**MODEL: 2008~2010 NINJA® ZX™ -10R (ZX1000E8F/E8FL/E9F/E9FA/E9FAL/E9FL/FAF/FAFA/FAFAL/FAFL)  
2009~2012 NINJA ZX-6R (ZX600R9F/R9FA/R9FAL/R9FL/RAF/ RAFA/RAFAL/RAFL/RBF/RBFL/RCF/RCFL)**

**TITLE: VOLTAGE REGULATOR REPLACEMENT**

## RECALL

## Repair Verification

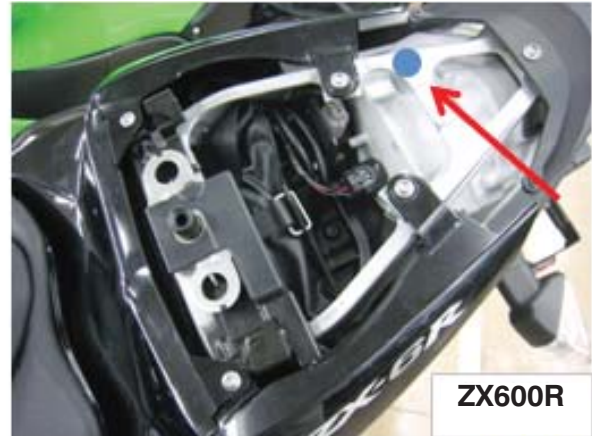
After repair, make a blue paint mark on the right side of the frame under the rear seat as shown.
